IREDELL COUNTY HEALTH DEPARTMENT

IMPROVEMENT PERMIT / AUTHORIZATION TO CONSTRUCT / OPERATION PERMIT / EXISTING SYSTEM

LOT 128 BELLS CROSSING SUBDIVISION

LOT 128
BELLS CROSSING SUBDIVISION
MOORESVILLE, NC
IREDELL COUNTY

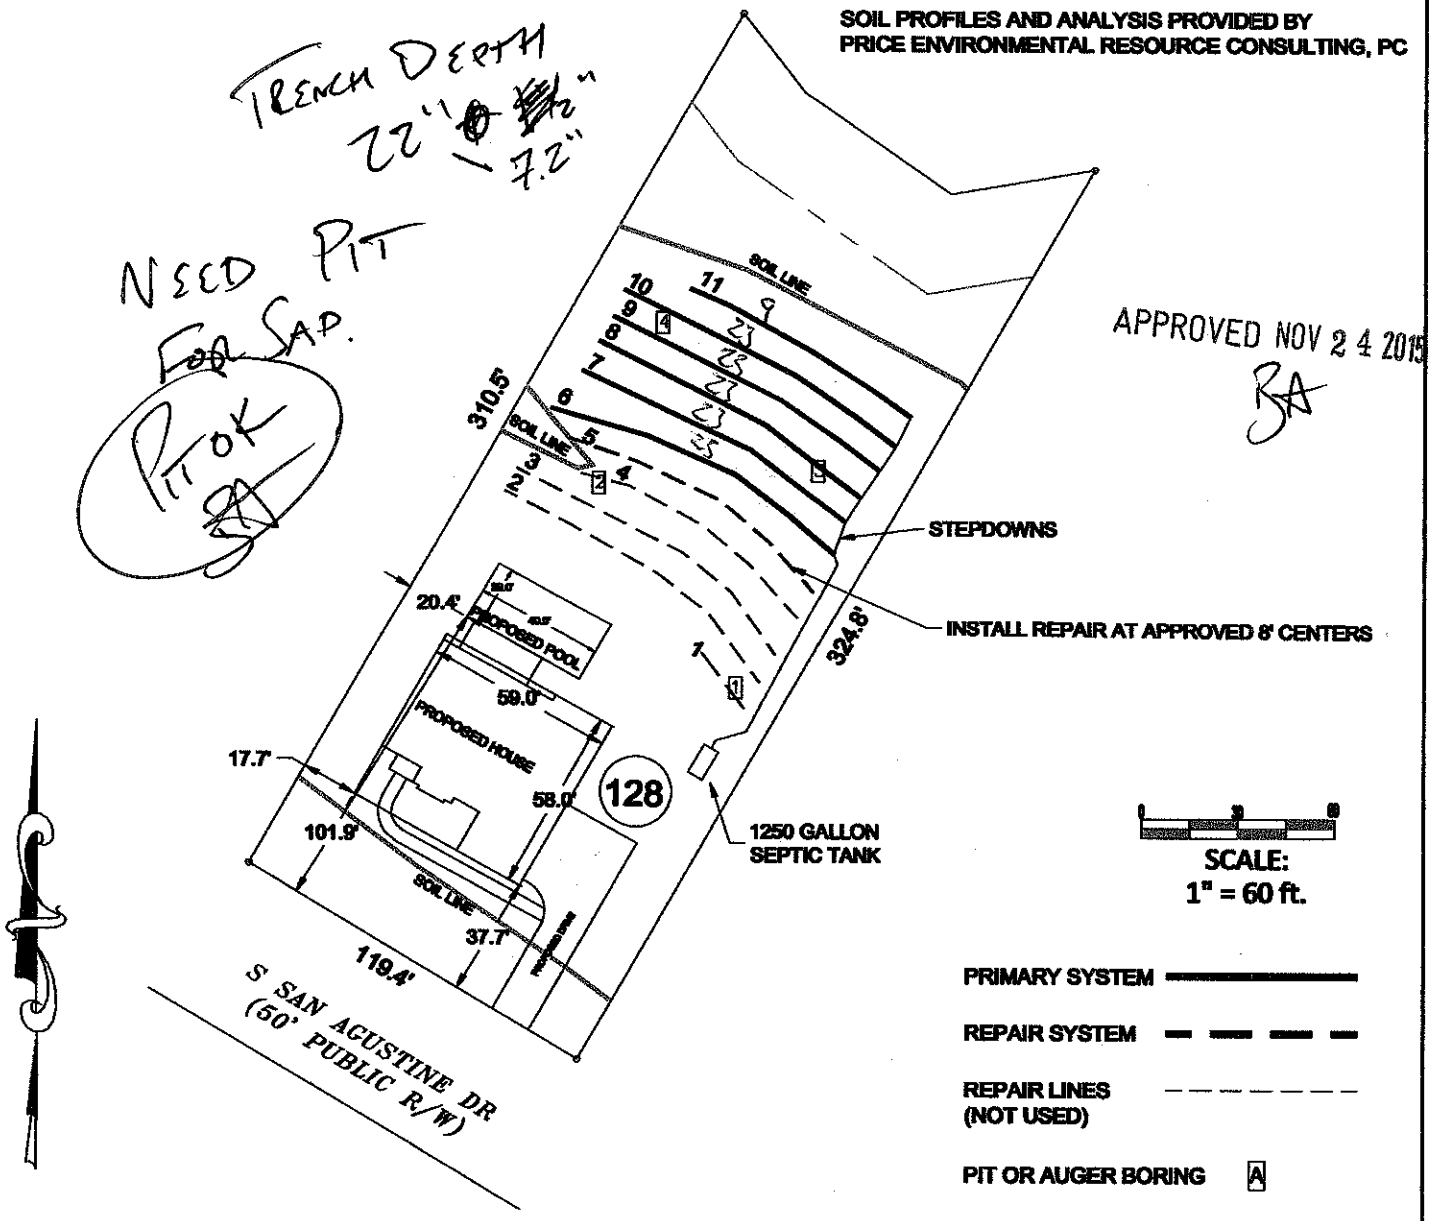
508' INSTALLED AS SHOWN BA

5-BEDROOM ACCEPTED STATUS GRAVITY SYSTEM
LINES 6-11 TOTAL 562 LINEAR FEET (USE 500FT)
EZFLOW OR CHAMBER
LTAR 0.3
~~25"~~ 15" TRENCH WITH 3" OF COVER ON THE HIGH SIDE

TRENCH DEPTH
22" ~~0~~ ~~1/2~~"
- 7.2"

NEED PIT
FOR SAP.
PIT OK

Comments / Conditions: BRING IN 3" COVER
